**Applicant's Response to Center for Biological
Diversity Data Requests dated March 15, 2012
for the APPLICATION FOR CERTIFICATION
for the Rio Mesa Solar Electric Generating Facility
(Rio Mesa SEGF)**

(11-AFC-04)

Subject: Response to Center for Biological Diversity Data Requests dated March 15, 2012
Rio Mesa Solar Electric Generating Facility (11-AFC-04)

KIT FOX OBSERVATIONS
RIO MESA SOLAR
ELECTRIC GENERATING FACILITY

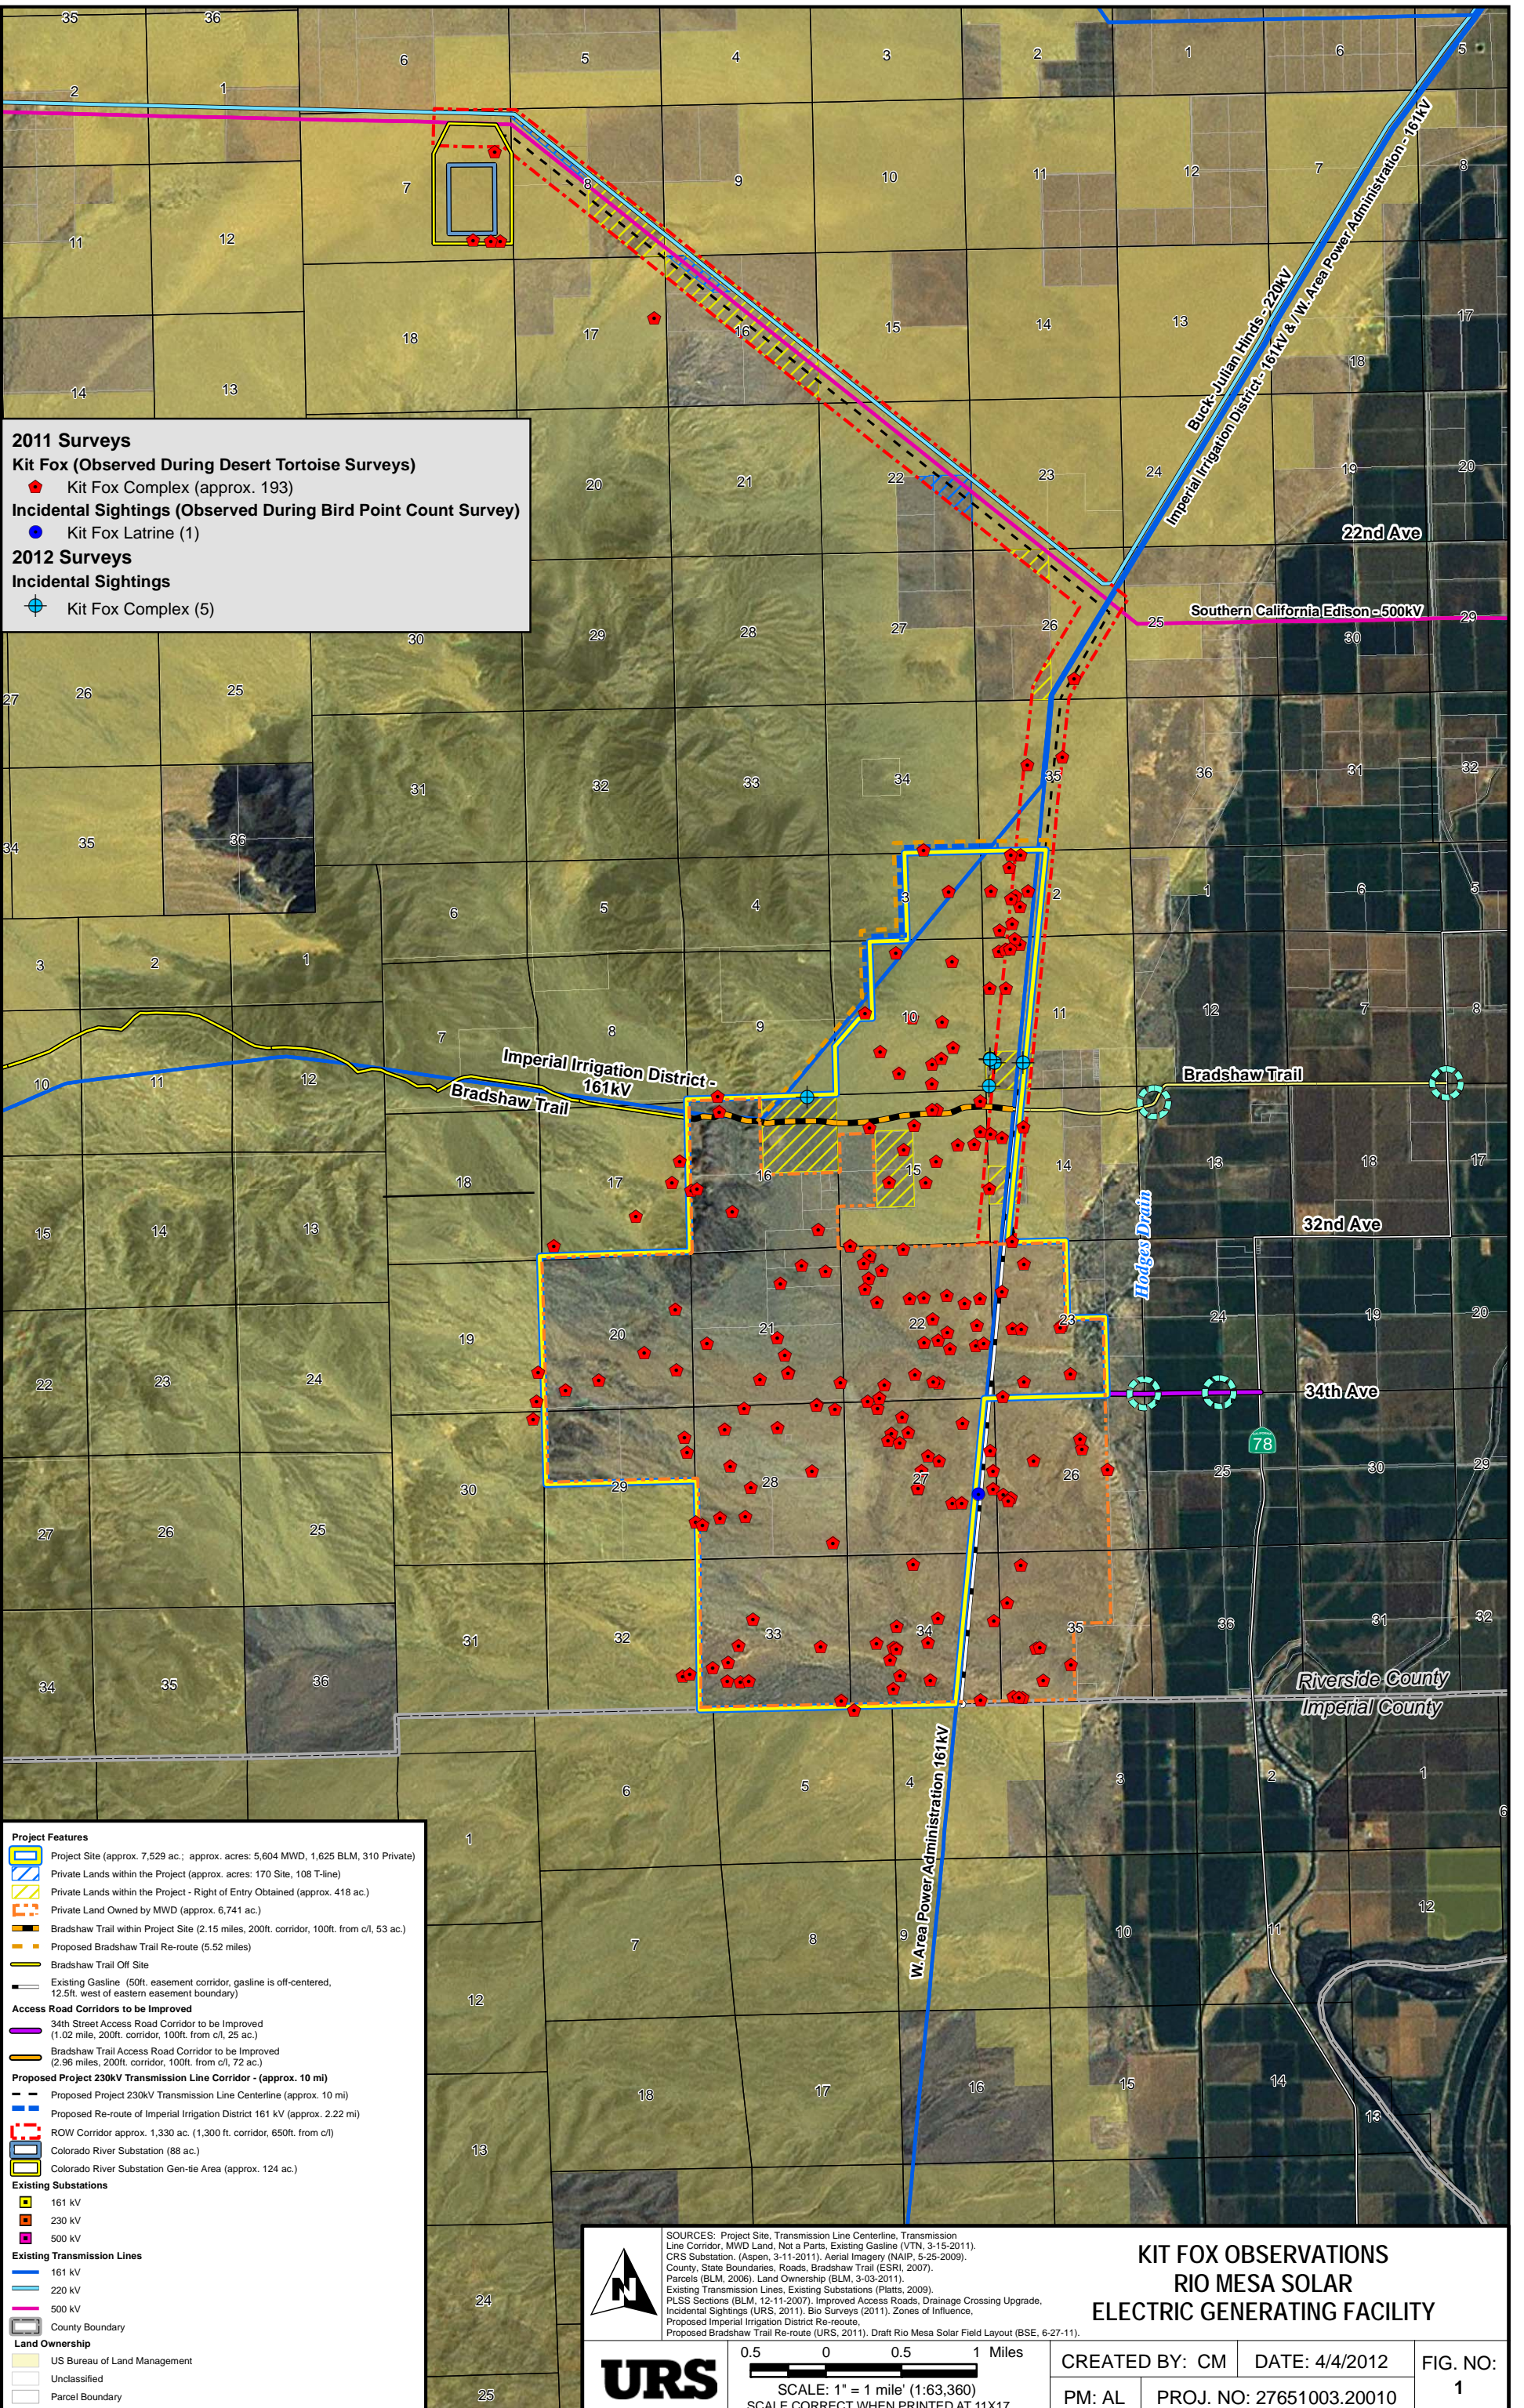
- 1. Please provide information on the type of kit fox sign (scat, tracks, and dens) on the proposed site and adjacent off-site areas. Data requested includes a map showing the locations of kit fox sign, kit fox dens and complexes including the number of burrows and whether they are natal or satellite dens and an estimate of the on-site and adjacent population.*

While desert kit fox den complexes were prevalent in the [Biological Study Area] BSA (193 observed), many den complexes occur within the home ranges of each single female and can be used for birthing or as refuges from coyotes. The species is solitary except during the breeding season and does not maintain territories. A birthing den is chosen in September or October after a female visits most of the dens in her home range. She cleans one for birthing. A female usually uses one complex for birthing that is three to four kilometers from the nearest neighbor to ensure a good hunting home range. Pups are born in February or March and are weaned by June. Den changes are frequent during the summer when puppies are being fed. At three to four months the pups begin to forage with the parents. In October the pups leave their parents' home range. Young foxes may travel long distances (30 or more km) before settling down. With kit fox ranges varying from 1 to 2 square miles (Morrell 1972; O'Farrell, and Gilbertson. 1979). The 193 den complexes observed may only represent 8 to 16 home ranges on site. Figure 6 in the BTR includes kit fox sighting locations. The den distribution was used to make this estimate. Other sign, such as scat and tracks, were associated with the dens.

See also attached Figure 1 (Kit Fox Observations) Map.

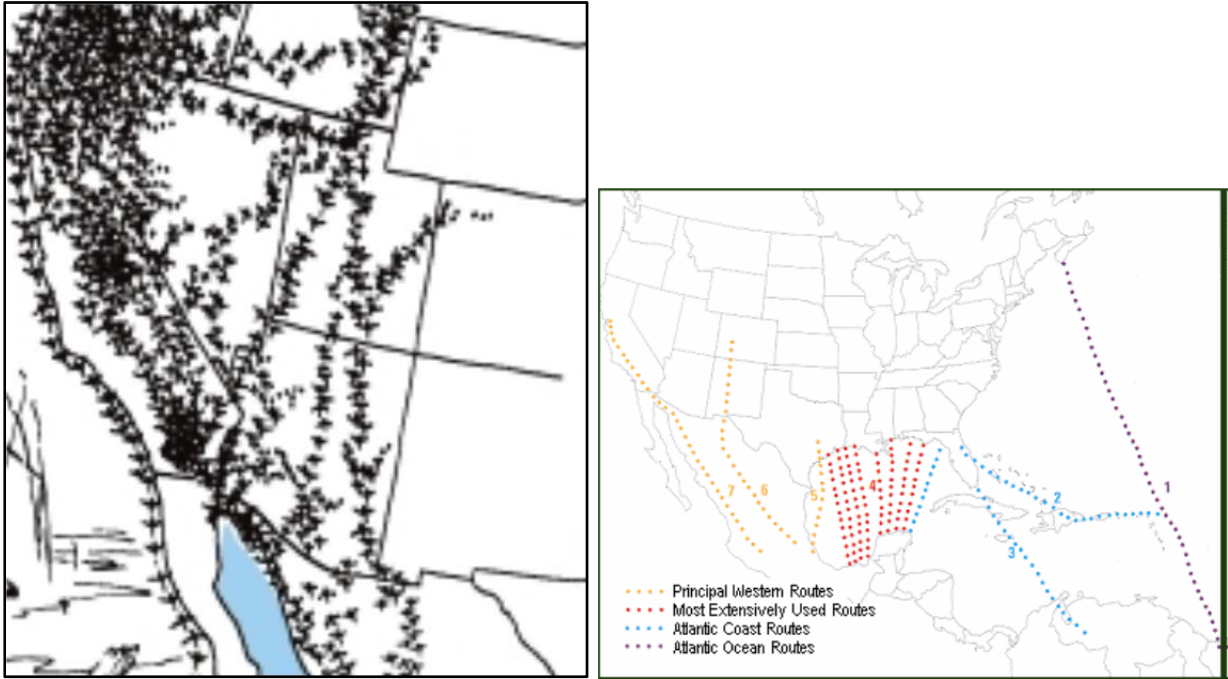
2b. *Please provide data on migratory pathways in the general area of the proposed project.*

Riparian areas along the LCRV provide some suitable habitat for a number of migratory shorebirds and wintering waterfowl. The Cibola National Wildlife Refuge located approximately 7 to 15 miles to the south of the Project site offers this preferred habitat and typically receives a portion of the migratory birds using the Pacific Flyway. Because desert scrub habitat does not provide the abundant resources required by migratory waterfowl and shorebirds, these birds are restricted primarily to the nearby river, and adjacent riparian areas.
